# Technical Service Bulletin

Technical Service Bulletin: tsb100242

New FS1006 Fuel Filter

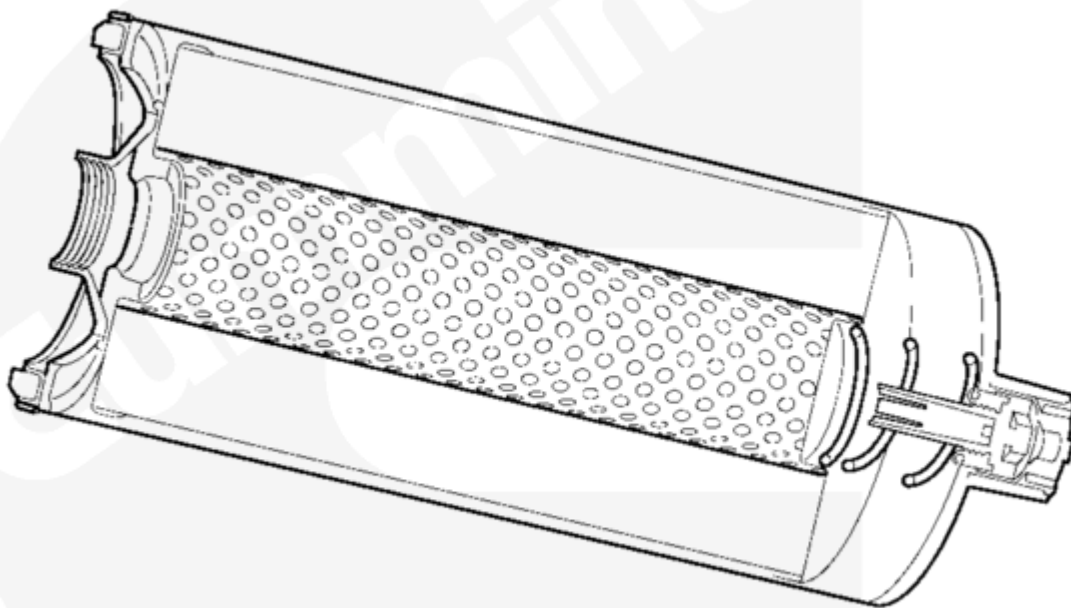
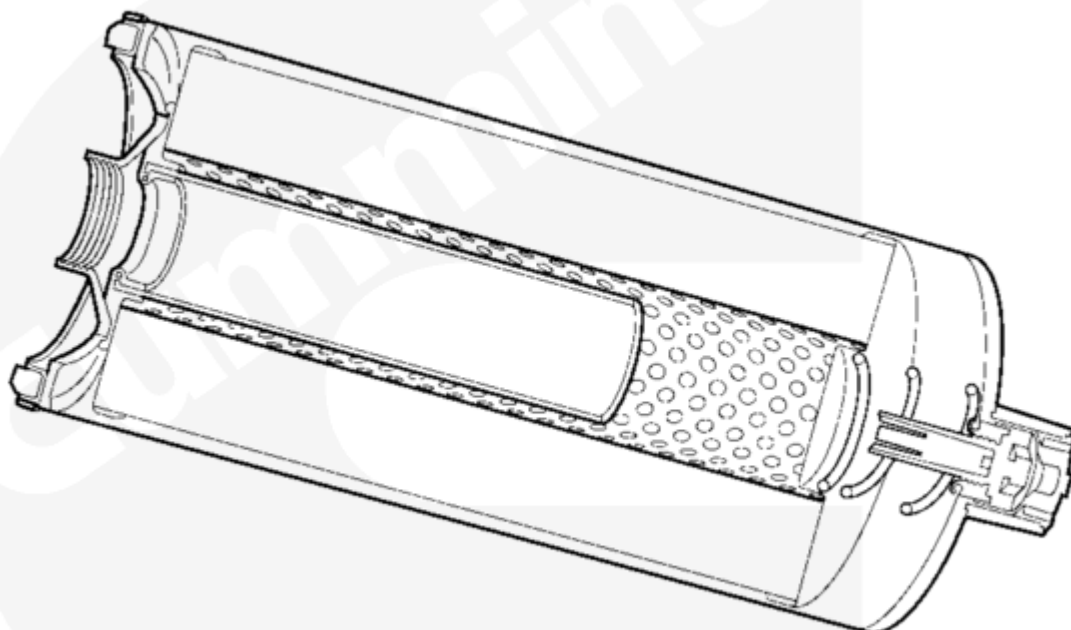
This Service Parts Topic introduces the new-style FS1006 fuel filter as the replacement to the old-style FS1006. The new-style fuel filter now incorporates a droptube to help prevent hard start events on some High Horsepower engines due to air in the fuel filters being allowed to flow to the fuel pump.

There are no external differences in appearance between the old and new-style filters.

The old Part Number 3089916, (figure 1), has been made obsolete and supersedes to Part Number 4095189 (figure 2).

A non-droptube version is no longer in production.
